[Docket No. FAA–2023–1814; Project Identifier AD–2023–00773–T; Amendment 39–22541; AD 2023–17–14]

### Airworthiness Directives; The Boeing Company Airplanes

**ACTION:** Final rule; request for comments.

**Figure 1 to paragraph (h)(4)—Cap seal minimum thickness (all dimensions in inches)**

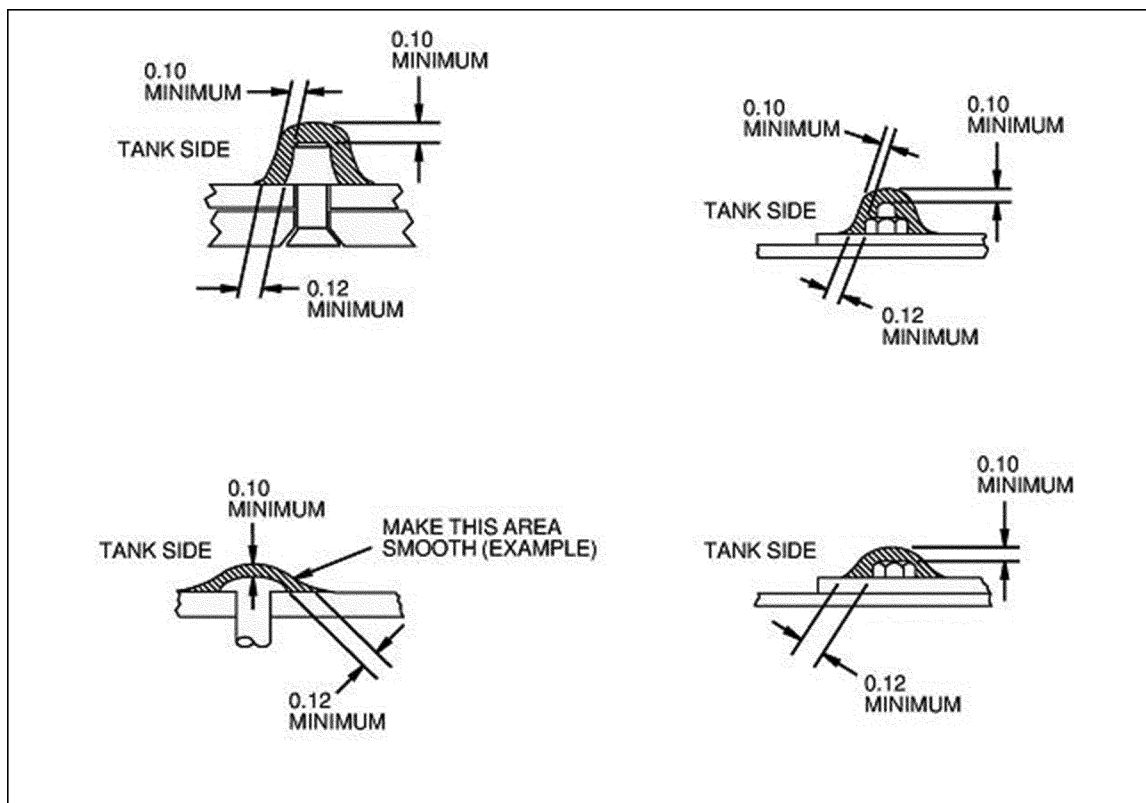
(4) During application of any cap seal to a fastener, fastener head, and fastener threads and collars, as required by this AD, the cap seal must be applied with a thickness equal to or greater than the dimensions specified in figure 1 to paragraph (h)(4) of this AD.

(6) Where Boeing Alert Requirements Bulletin 777-57A0122 RB, dated October 8, 2021, requires inspections that may require the removal of fastener cap seals, this AD requires that if the cap seal is removed, a cap seal of BMS 5-45 sealant be reapplied with a thickness equal to or greater than the dimensions specified in figure 1 to paragraph (h)(4) of this AD before further flight after completion of the inspection.

(ii) All cap seals were applied using procedures with thickness dimensions greater than or equal to those given in figure 1 to paragraph (h)(4) of this AD.

(2) If any cap seal was applied using procedures with thickness dimensions less than those given in figure 1 to paragraph (h)(4) of this AD, or if the maintenance records do not definitively specify the procedures used: At the applicable time specified in paragraph (i)(2)(i) or (ii) of this AD, replace the cap seal in accordance with the Accomplishment Instructions of Boeing Alert Requirements Bulletin 777-57A0122 RB, dated October 8, 2021, using a cap sealing procedure with thickness greater than or equal to the dimensions given in figure 1 to paragraph (h)(4) of this AD.
